NOTICE OF APPROVAL

Planning Case #: Design Study 19441

FINDINGS & CONDITIONS FOR DESIGN STUDY APPROVAL

DS 19-441 (Minelli)
Santa Fe 2 NE Mountain View
Block/Lot: 81/18
APN: 010-045-014
Date of Action: May 8, 2020

A2

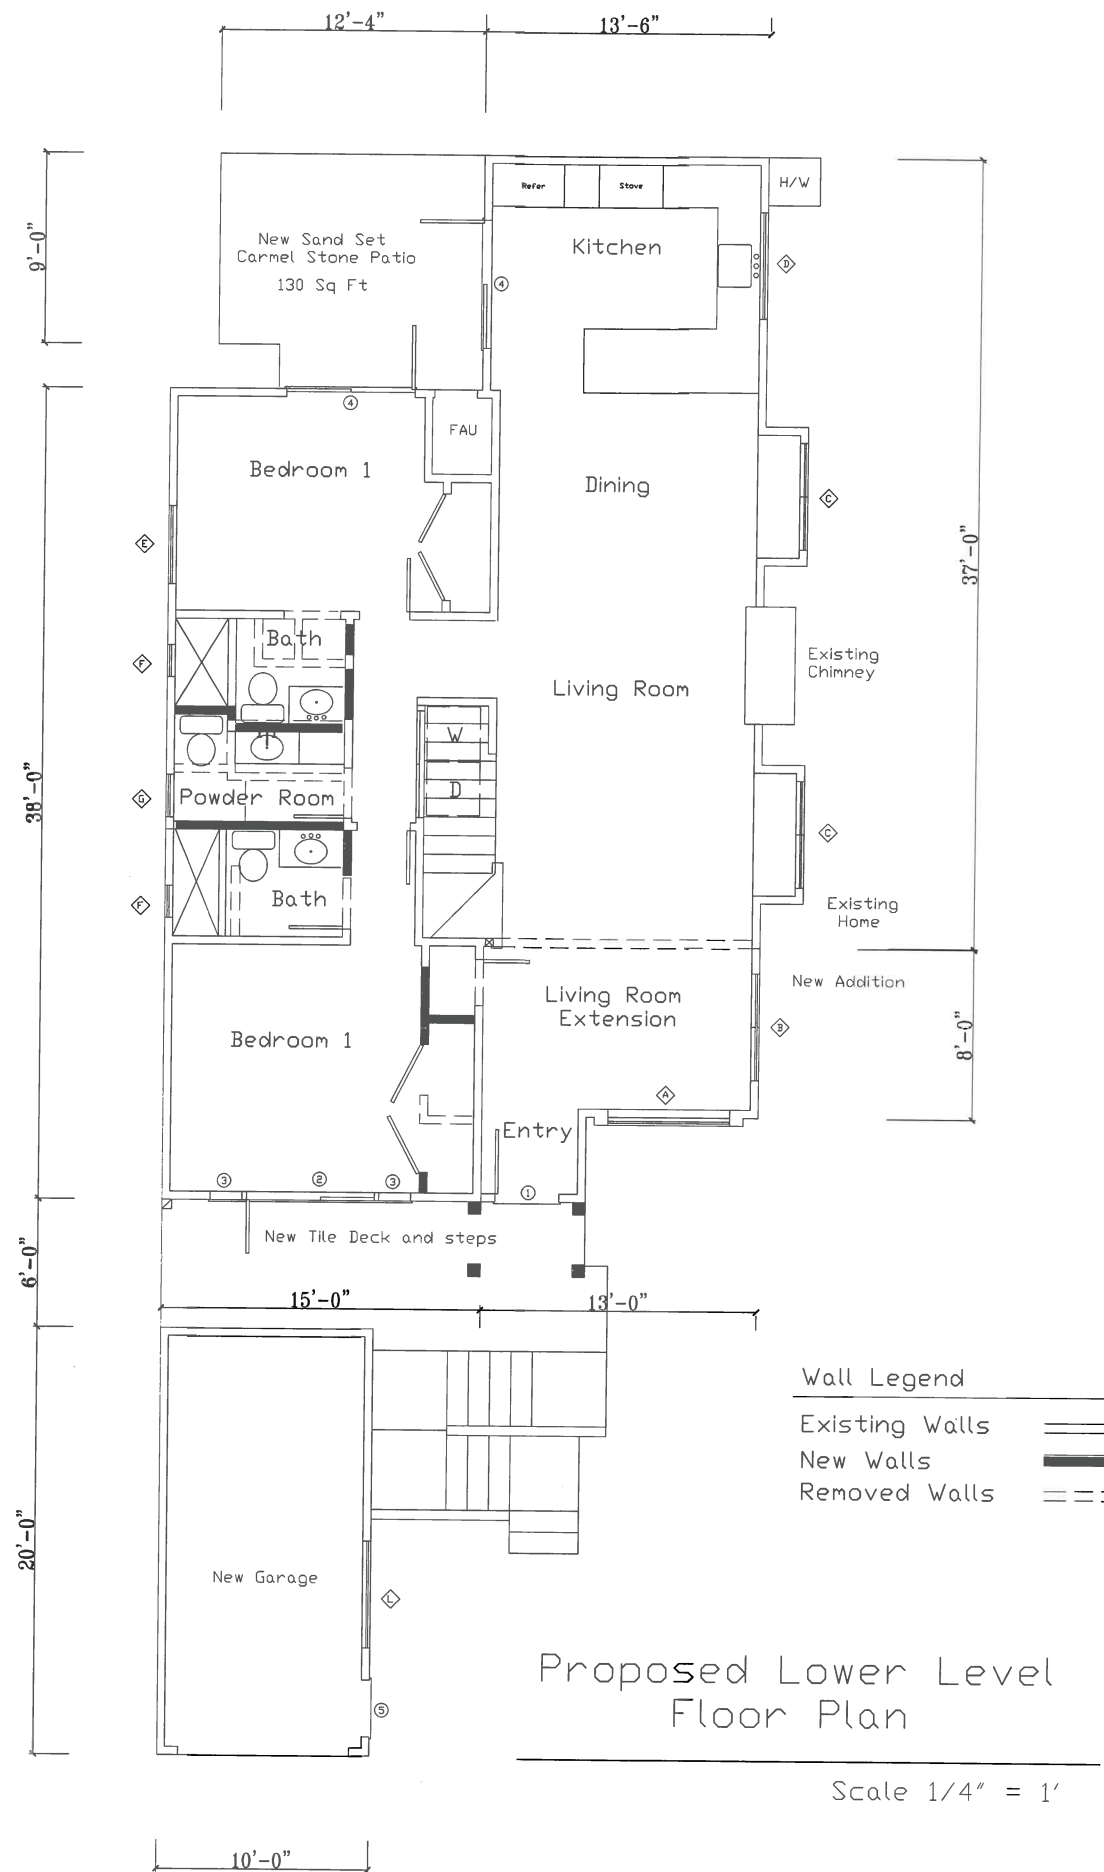
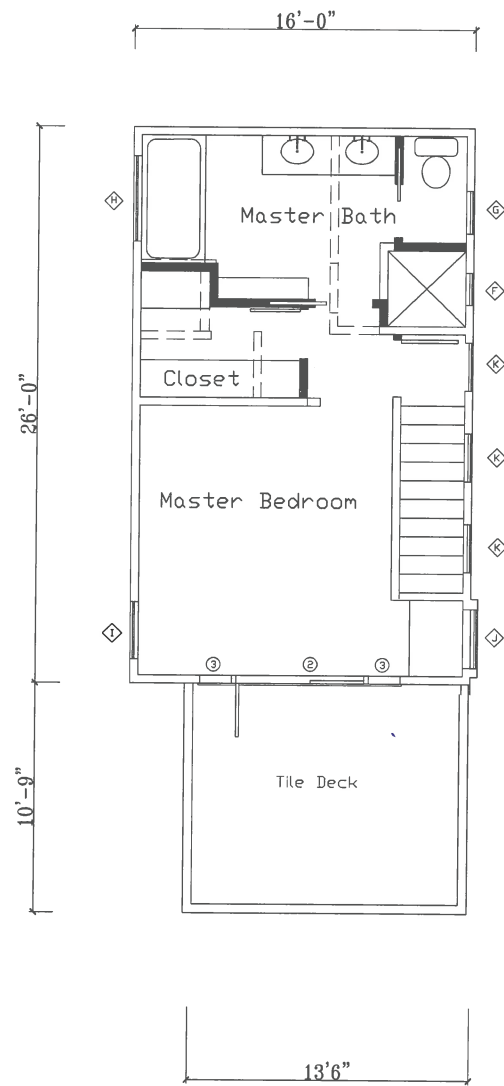
sound and dust.	
28.	Demolition shall be consistent with the demolition plan on sheet A2 of the approved plan set. Demolition of additional exterior walls may require Planning Commission approval. The existing exterior wall cladding may be removed as needed; however, the existing framing shall remain and removal of walls shall be consistent with the demolition plan.	✓

A3

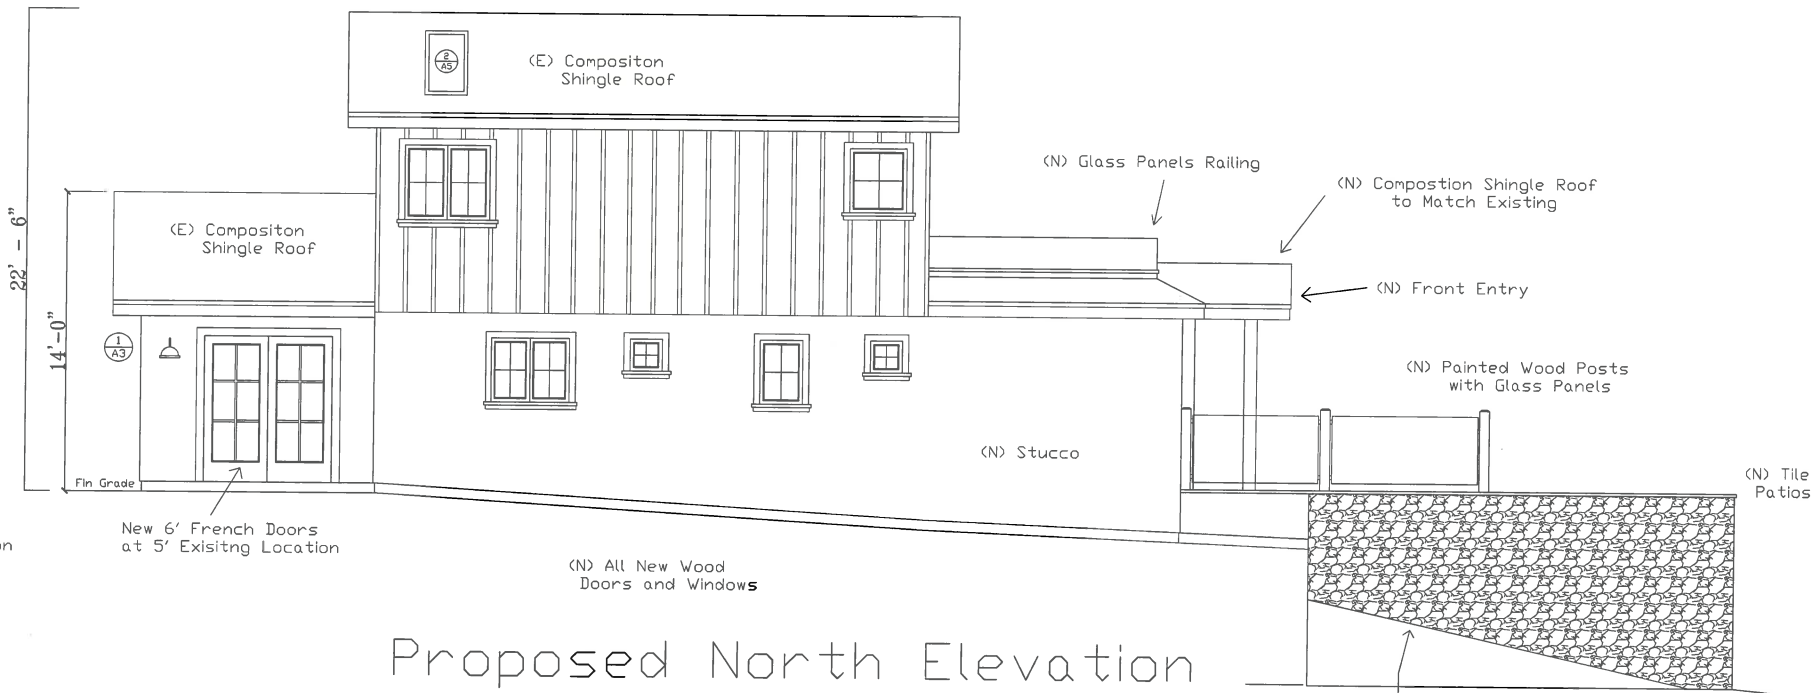
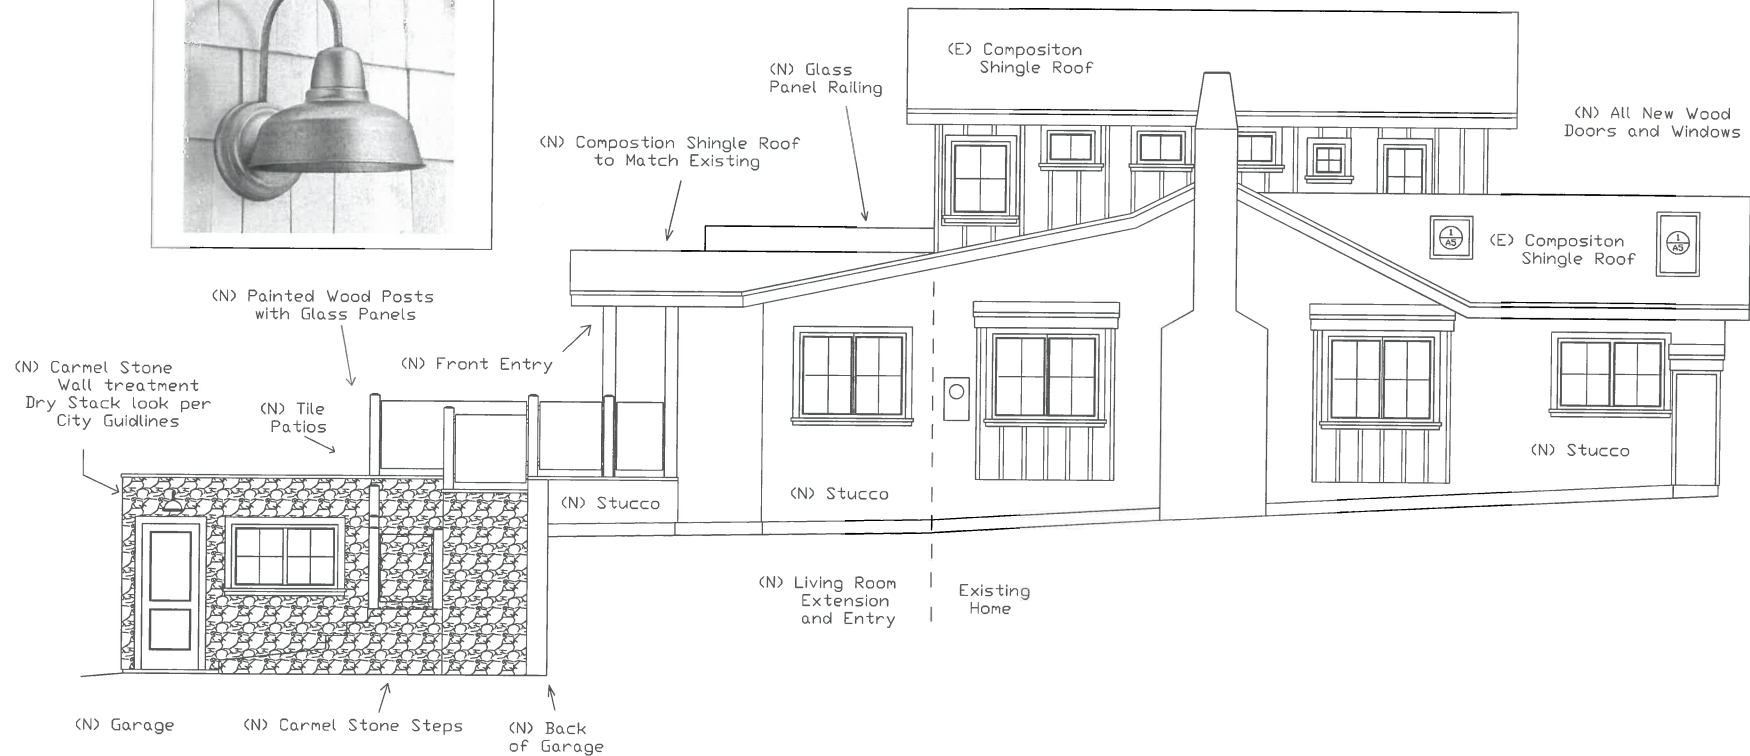
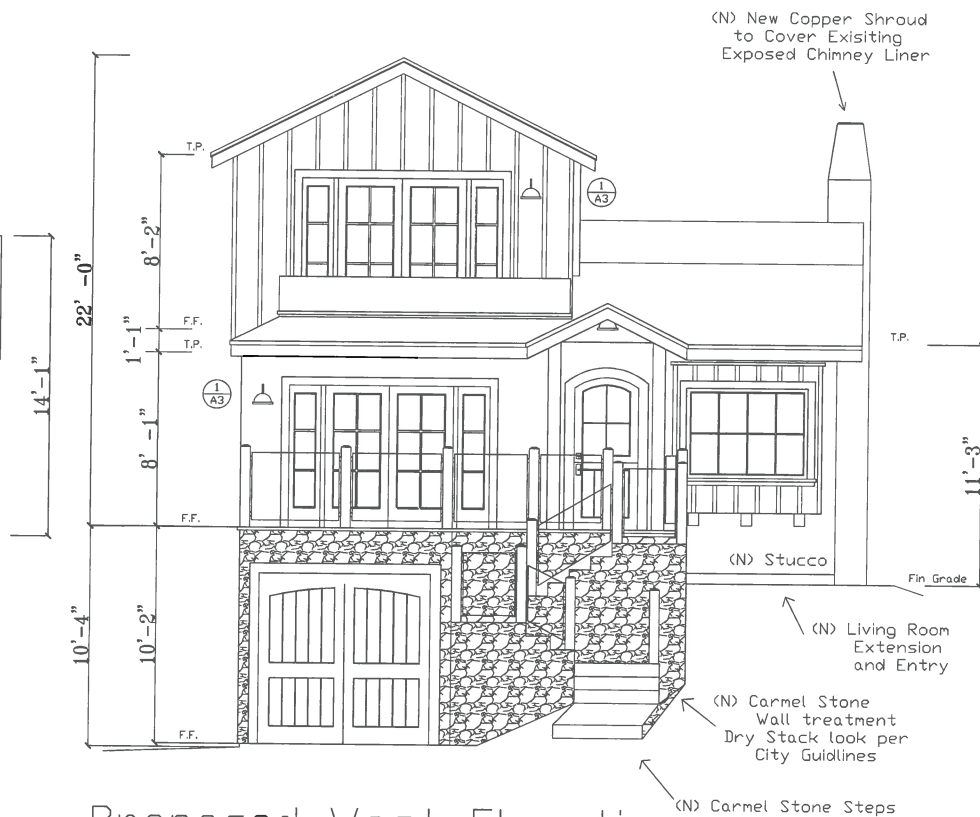
29.	The deck area over the garage shall not be expanded. The roof deck shall not be expanded beyond 90 square feet, as indicated on the approved plans.	✓
30	The first floor shall be stucco throughout. The proposed board and batten bay windows shall be revised to have a stucco finish on the building plan set.	✓
